CLEARFIELD CITY PLANNING COMMISSION MEETING AGENDA

SUBJECT: Discussion and Possible Action on **PSP 2020-120023**, a preliminary subdivision plat request by Paul Poteet with Liberation Development Investments, LLC for a 1-Lot subdivision at the subject location. **Location:** 311 East 200 South (TIN: 12-001-0186 & 12-007-0112). **Parcel Area:** 3.445 acres. **Zone:** U-C (Urban Core Commerce). **Planner:** Brad McIlrath (**Administrative Action**).

SUBJECT: Discussion and Possible Action on **SP 2020-120068**, a site plan review request by Robert Fahrenbacker with ALC Architecture, to construct a drive-through beverage establishment at the subject location. **Location:** 585 North Main Street (TIN: 14-530-0002). **Parcel Area:** 0.49 Acres. **Zone:** C-C (Gateway Corridor Commerce). **Planner:** Brad McIlrath (**Administrative Action**)

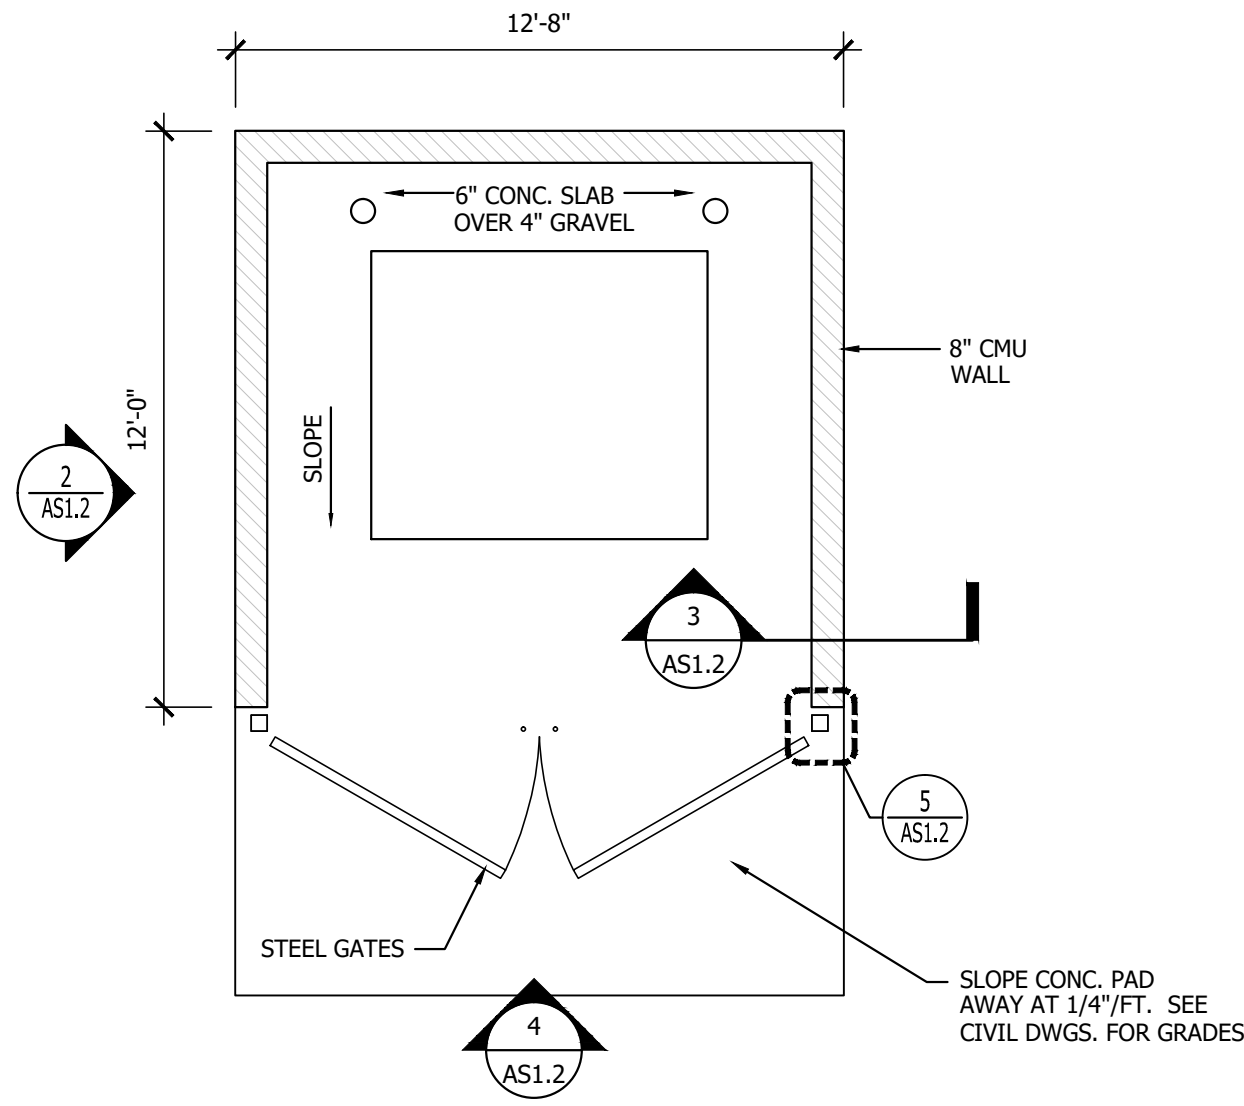
Enclosure must be a minimum of 10' from all property lines. 1 medium or large shade tree must be located in the landscaping around the enclosure. See code for sizing of large or medium trees.

A 5 foot planing strip must be located around the perimeter of the building except for areas with outdoor dining or entrances.

- Landscape island needs to be a minimum of 5' wide and extend the length of the parking spaces.

Subject: Text Box
Page Label: [2] 20-1855 L100 AR Landscape Plan-L1.1 Top is 1:10 bottom is 1:20
Author: Brad McIlrath, Senior Planner
Date: 12/31/2020 9:21:43 AM
Status:
Color: ■
Layer:
Space:

1 **WEST**
EAST EXTERIOR ELEVATION
SCALE: 1/4" = 1'-0"

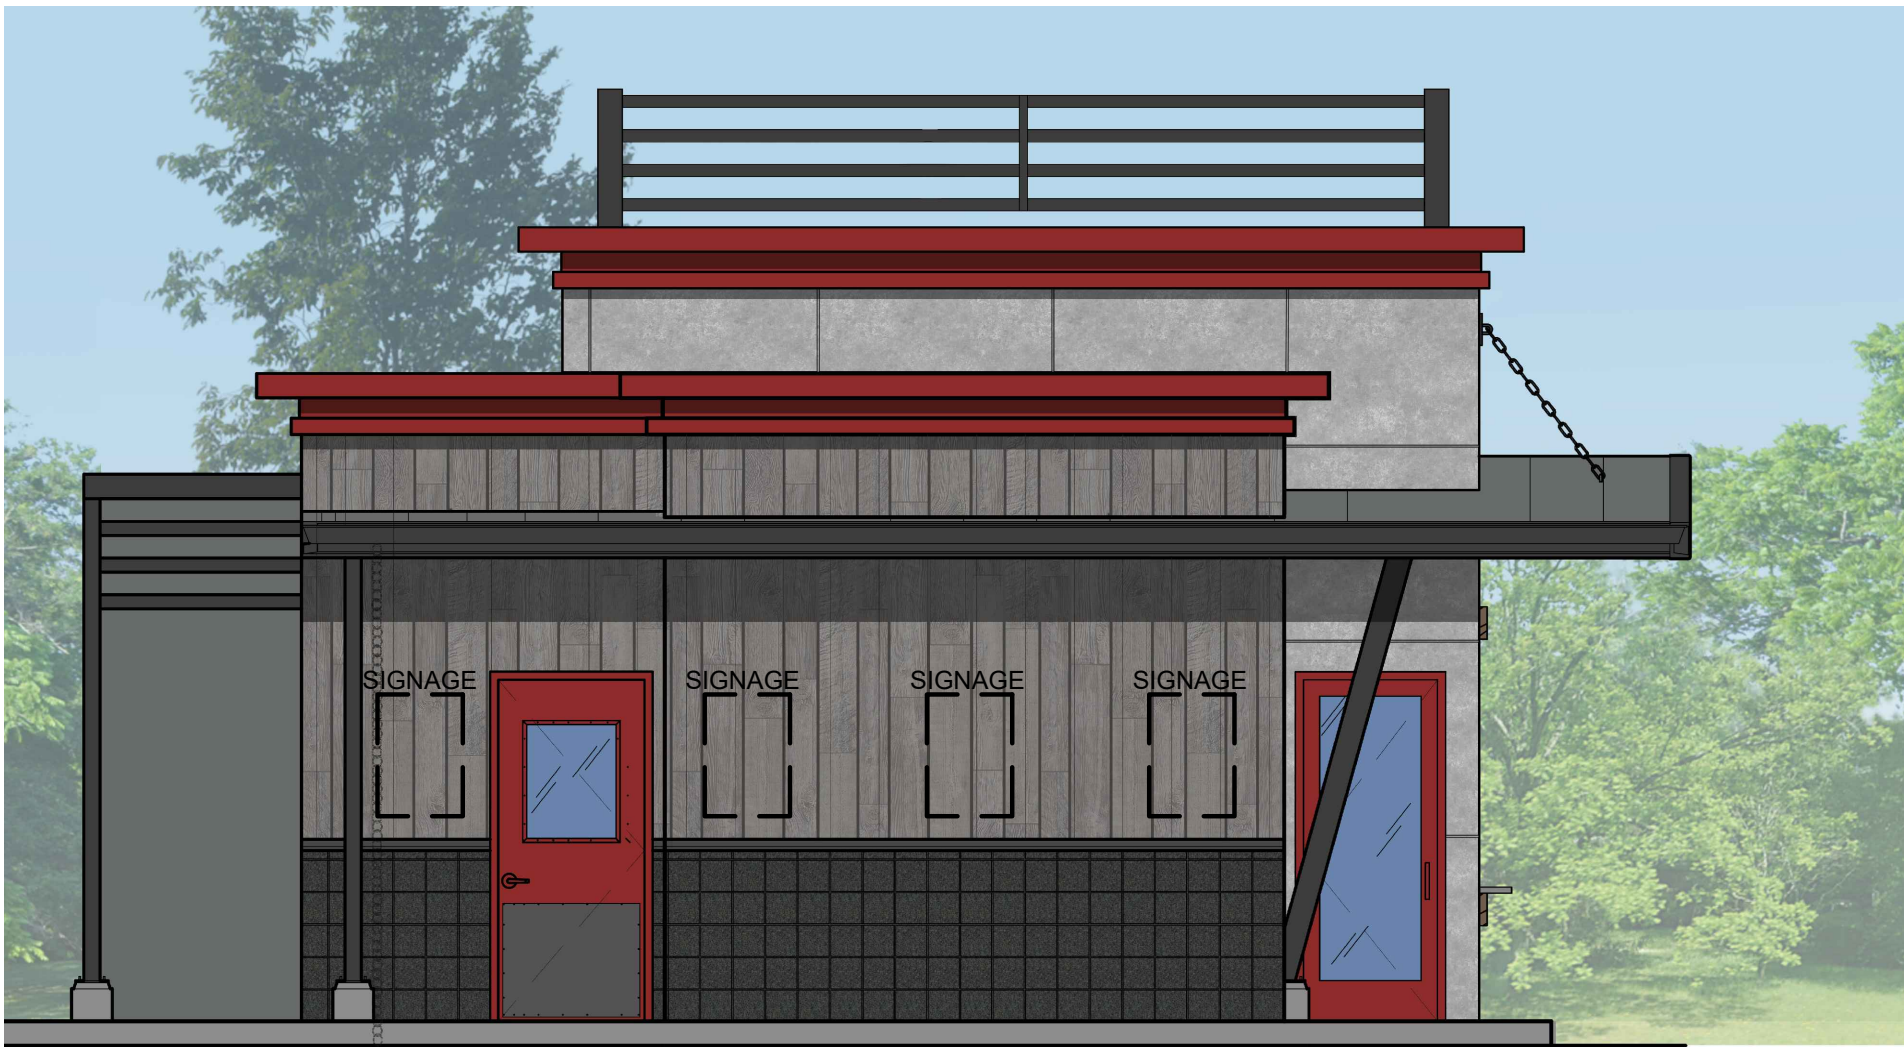
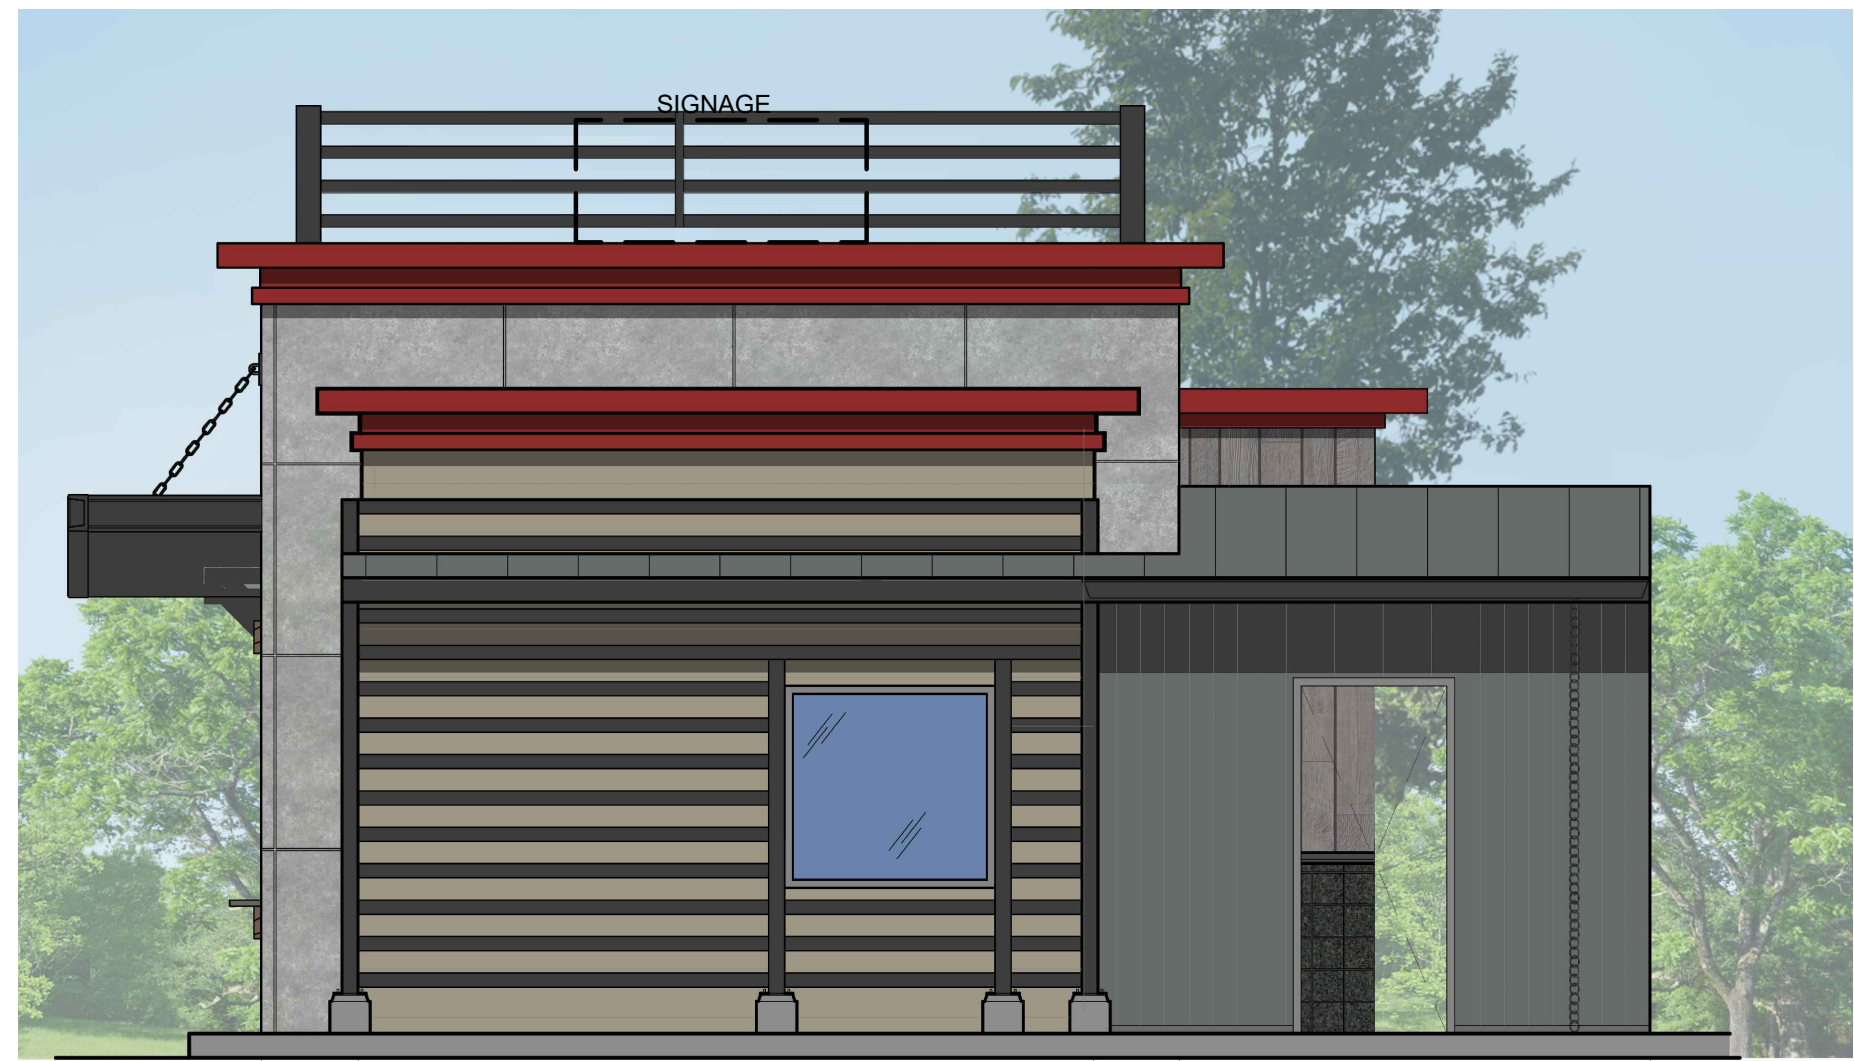
Subject: Length Measurement
Page Label: [1] 18117A-A3.1-Building Elevations-A3.1 20'-8"
Author: Brad McIlrath, Senior Planner
Date: 12/31/2020 9:23:00 AM
Status:
Color: ■
Layer:
Space:

Subject: Text Box
Page Label: [1] 18117A-A3.1-Building Elevations-A3.1 SOUTH
Author: Brad McIlrath, Senior Planner
Date: 12/31/2020 9:23:03 AM
Status:
Color: ■
Layer:
Space:

Subject: Text Box
Page Label: [1] 18117A-A3.1-Building Elevations-A3.1 NORTH
Author: Brad McIlrath, Senior Planner
Date: 12/31/2020 9:23:13 AM
Status:
Color: ■
Layer:
Space:

Subject: Text Box
Page Label: [1] 18117A-A3.1-Building Elevations-A3.1 WEST
Author: Brad McIlrath, Senior Planner
Date: 12/31/2020 9:23:21 AM
Status:
Color: ■
Layer:
Space:

Subject: Text Box
Page Label: [1] 18117A-A3.1-Building Elevations-A3.1 EAST
Author: Brad McIlrath, Senior Planner
Date: 12/31/2020 9:23:24 AM
Status:
Color: ■
Layer:
Space:

Subject: Area Measurement
Page Label: [1] 18117A-A3.1-Building Elevations-A3.1 18 sf
Author: Brad McIlrath, Senior Planner
Date: 12/31/2020 9:23:27 AM
Status:
Color: ■
Layer:
Space:
